# Boston Overflight Noise Abatement Study

## Progress Update Report

April 20, 2006

Alternative 5 RNAV Procedure Update (Depicts Westflow only)

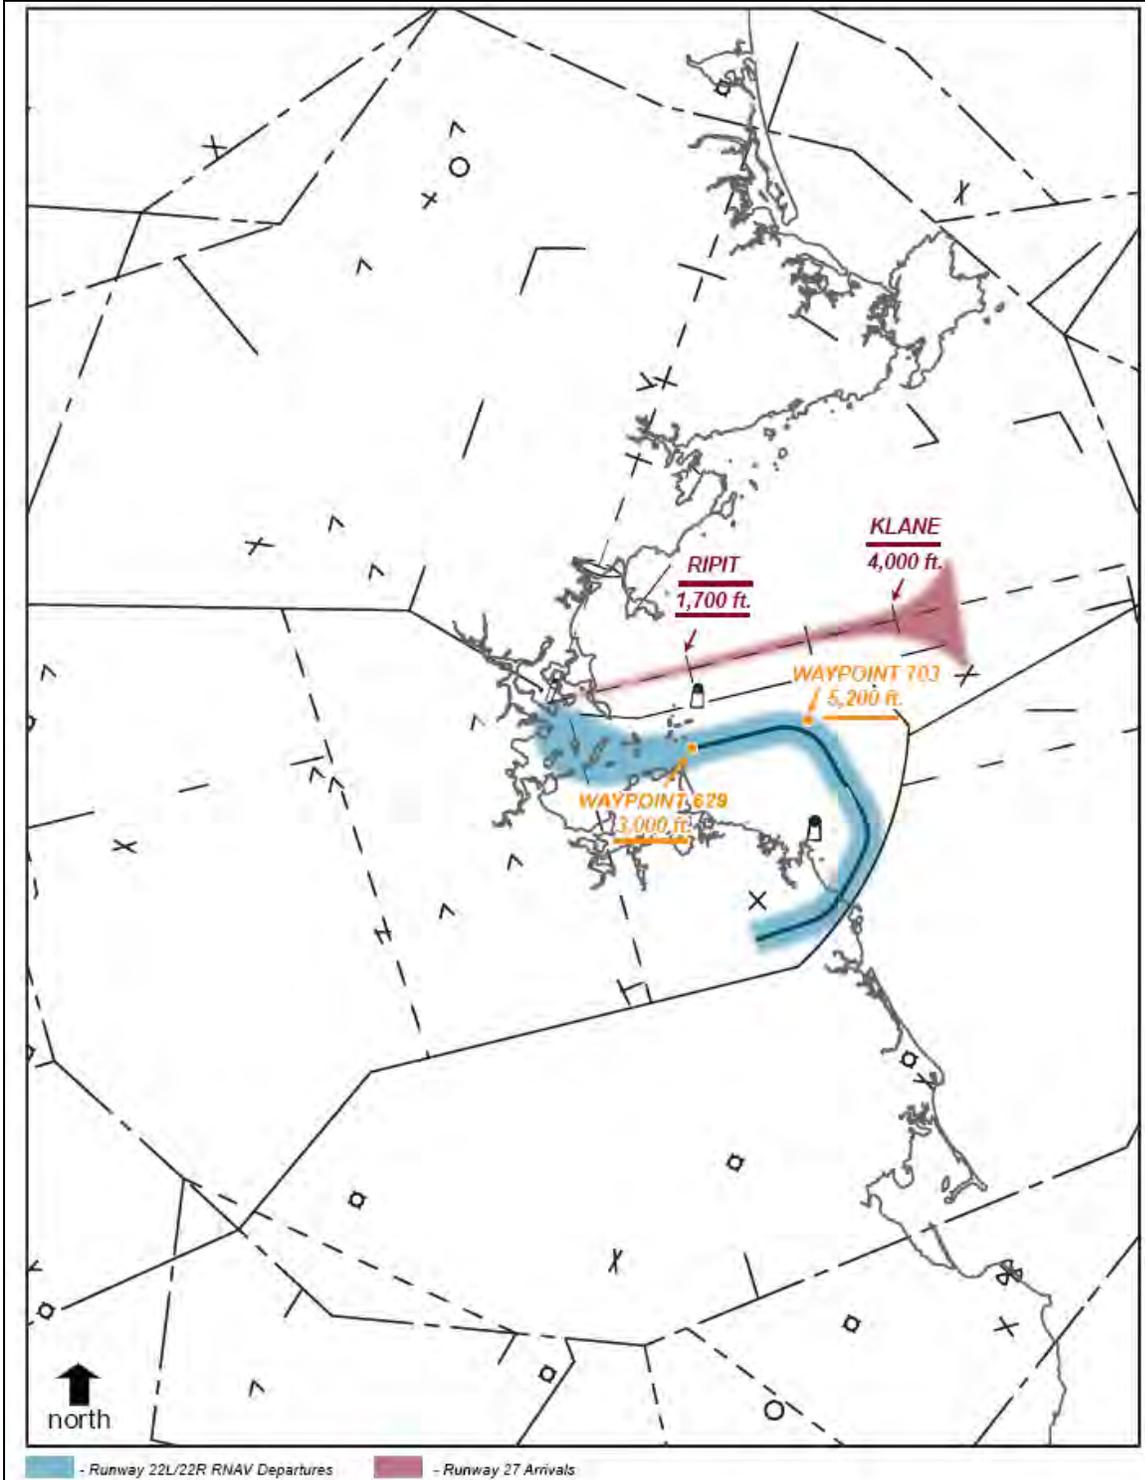
- Alternative corridors have been forwarded to Wyle for noise analysis.
  - Additional considerations:
    - Runway 22L/22R RNAV Departure (Alternative 5): PC conducted a final assessment of this RNAV alternative. The main issue addressed was the lateral separation requirement between the eastbound portion of the RNAV and Runway 27 final approach. A memorandum summarizing the final design was submitted to BOS/TAC for review March 20<sup>th</sup> (**see Attachment 1**). A BOS/TAC teleconference meeting was held March 30<sup>th</sup> to discuss the content and provide PC direction. BOS/TAC instructed PC to proceed with noise analysis. Teleconference meeting notes were developed (**see Attachment 2**). **Exhibit 1** illustrates the additional elements added to the RNAV procedure. The waypoint locations are identical to the procedure presented on February 17<sup>th</sup>. The altitude requirements stated for Runway 27 arrivals and Runway 22L/22R departures is an additional component to the final design.

TARGETS Illustration Northwest RNAV Design Update

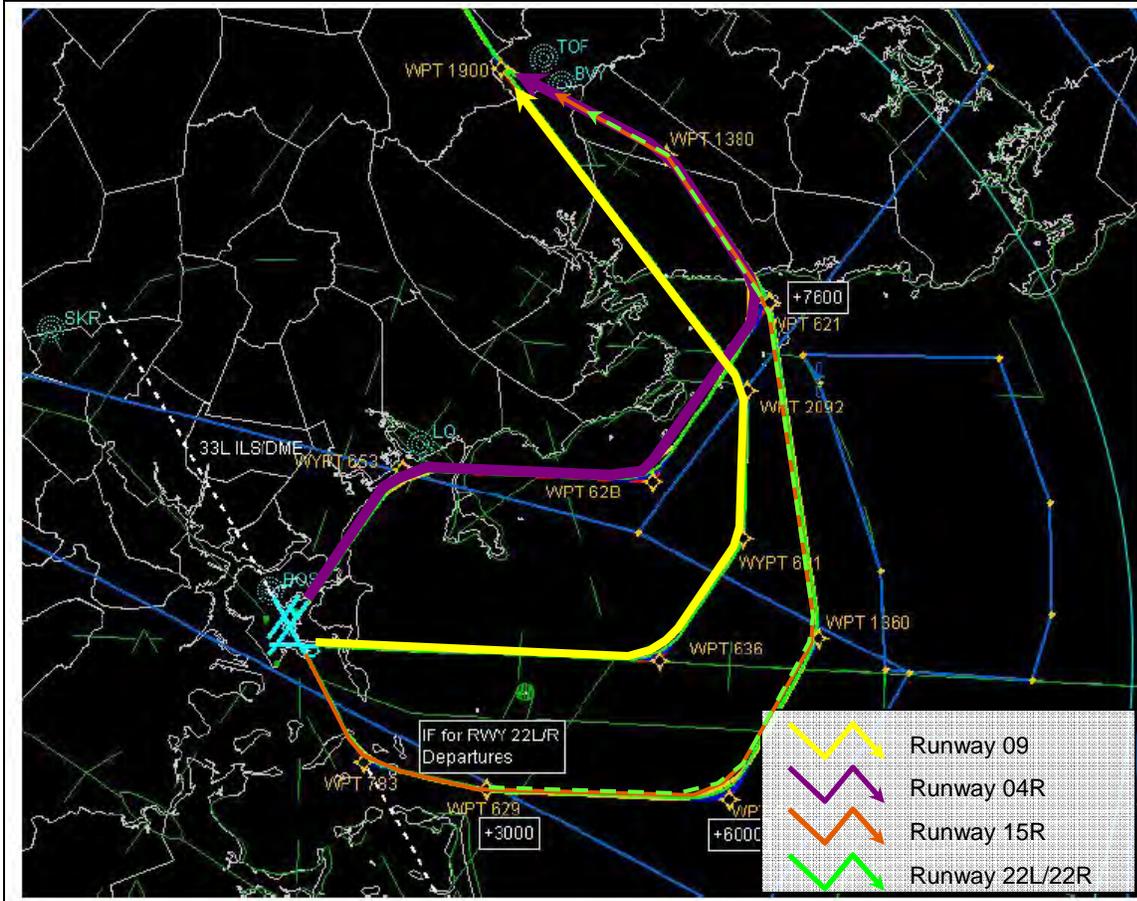
- Runway 22L/22R RNAV Northwest Departure (Alternative 5/14): Per BOS/TAC direction, PC has completed a design to split Runway 09 and Runway 22L/22R shoreline crossing locations along the northwest corridor. **Exhibit 2** shows a TARGETS (FAA's RNAV design tool) illustration of the updated northwest RNAV routes for Runways 04R, 09, 15R and 22L/22R. The purpose for this change was to disperse Runway 09 and Runway 22L/R departures when crossing over the shore towards the northwest. The Acrobat illustrations will be updated to reflect the change.

## Alternative 5 RNAV Procedure with Required Altitude Crossings

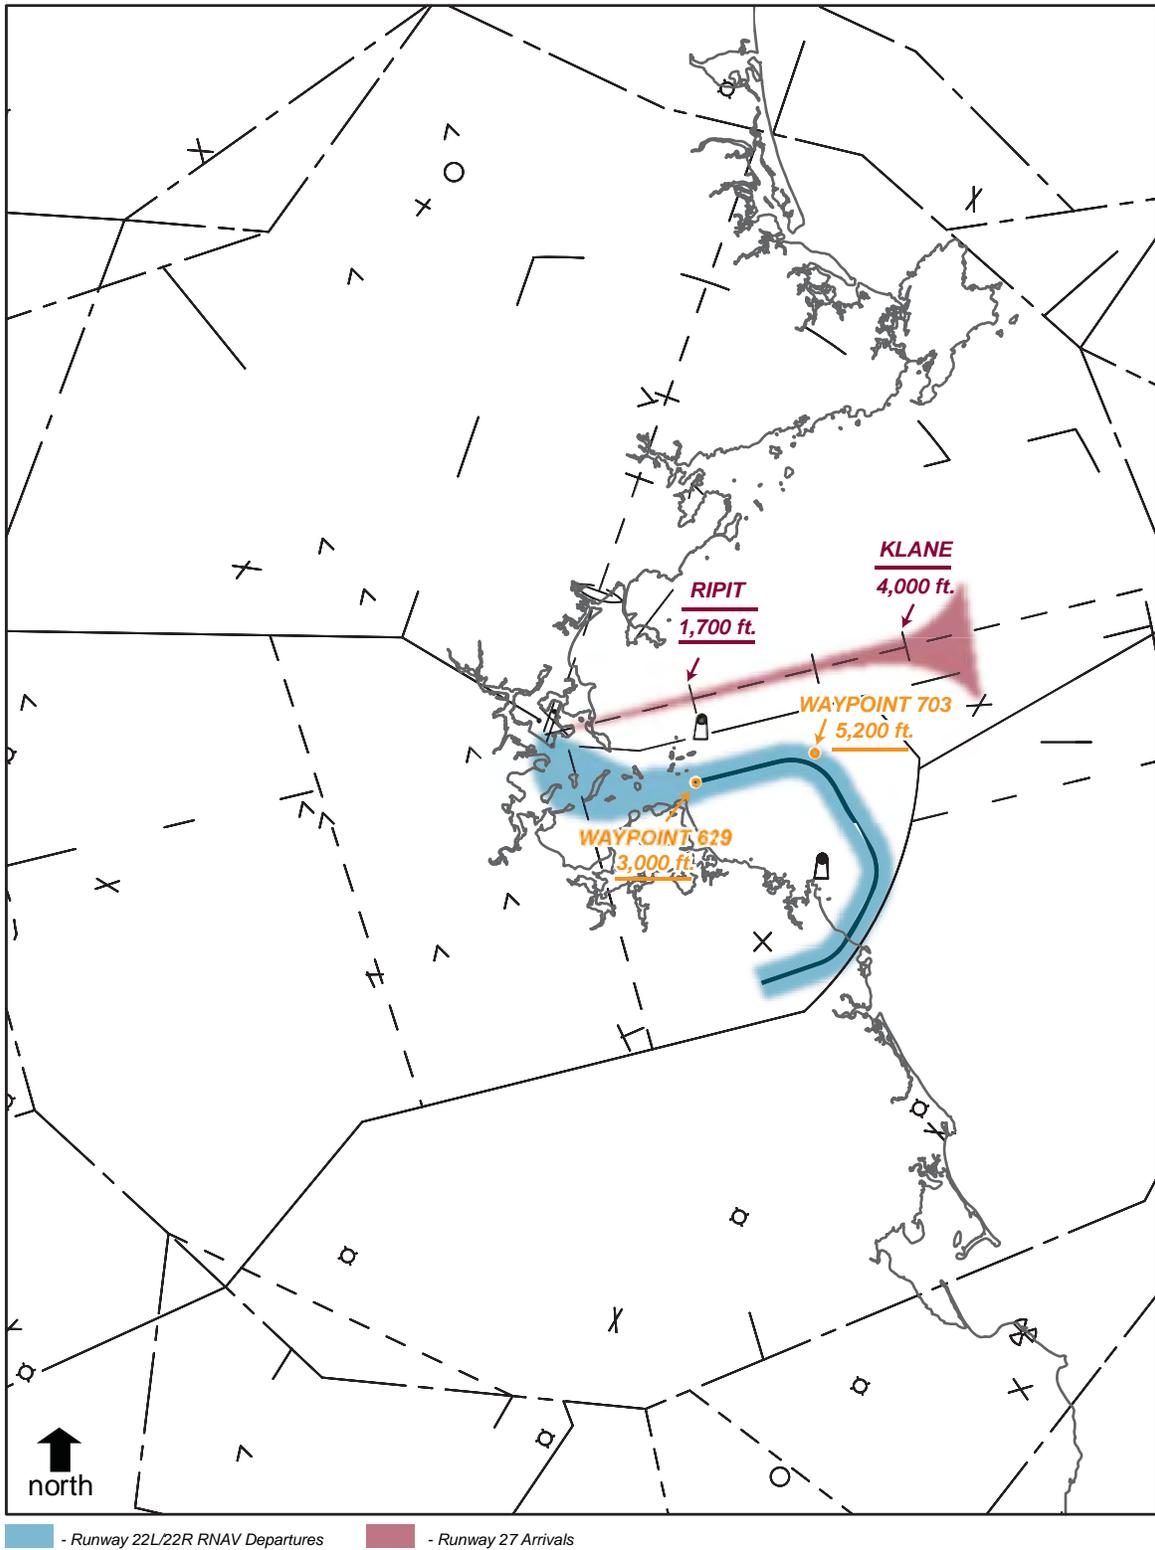
- 1) The initial waypoint may be moved 0.2 Nautical Miles (NM) south and still meet the east end (shoreline crossing) criteria to remain inside the existing TRACON and Center boundaries. However, this will not resolve the Town of Hull's concerns and will trigger additional RNAV design issues, including a turn radius above the recommended 70 degrees, and a reduced average shoreline crossing altitude (by approximately 900 ft less than previously planned average which is at 13,000 ft Mean Sea Level or MSL).

- 2) The procedure cannot be re-designed to meet the FAA's stated lateral separation requirements of 4.12 NM between the Runway 27 final approach course and RNAV center line (3.5 NM from expected edge of the corridor), and remain within the agreed upon criteria to remain within the TRACON and Center boundaries. When aircraft turn back towards the west, they are directed to a specific BOS Center sector (west of the TRACON departure sector). This BOS Center sector is responsible for the safe and expeditious movement of westbound aircraft transitioning from the terminal area to enroute. The RNAV design criteria does not allow for a sharper turn to the west in order to transition into the responsible BOS Center sector, which would

- 1) The PC will develop the original Alternative 5, as presented on February 17<sup>th</sup>, with required altitude crossings for departure aircraft. As shown in the attached exhibit, departure aircraft will cross Waypoint 629 (located 6.3 NM from the end of Runway 22L, approximately 7NM travel distance (latitude: 42° 19' 21.12"/longitude: 70° 52' 30.63")) at or above 3,000 ft. MSL, and Waypoint 703 (latitude: 42° 20' 31.05"/longitude: 70° 45' 53.99") at or above 5,200 ft. MSL. Arrival aircraft will normally be at or below 4,000 ft. MSL turning to the final approach course, and will be required to cross the RIPIT intersection at 1,700 ft. MSL on the approach to Runway 27. This will procedurally provide the required FAA altitude separation of 1,000 ft. MSL between the arrival and departure aircraft while using this procedure. Though there is no known FAA criteria to support the concept of including altitude separation for this procedure, we believe that the 3.4 NM lateral separation from the Runway 27 final approach course that our design provides, in conjunction with the altitude separation provided, would make this alternative design a better candidate to be evaluated in the FAA's 18-step process compared to the original presented February 17<sup>th</sup> at the BOS/TAC meeting.

- 2) The vector to a fix RNAV design that we propose is based on new criteria developed within the last year. It is subject to interpretation and change, based on discussions with Flight Standards (AFS 420) personnel. The variables that dictate dispersion along the vectored pattern are the same for existing conditions. Controllers will issue a heading to waypoint 629 when radar contact is established and separation is established. Due to weather conditions, piloting and the time when the controller issues the heading, the point at which the turn is conducted is expected to vary. Therefore, PC assumed that the southern dispersion in this first segment of the departure procedure will be similar to existing conditions, but the dispersion on the north side of the corridor will be reduced as the aircraft will be heading towards waypoint 629. The waypoint is a fly-by waypoint, which does not require the aircraft to fly directly over the waypoint. The PC is predicting that traffic will be within the RNAV corridor just after passing waypoint 629. Prior to waypoint 629, in the vector to a fix segment, the dispersion may be narrower than the PC has predicted, but there is no objective means to justify a narrower dispersion at this time for BOS traffic conditions. Therefore, PC has decided to use a wider dispersion to be more
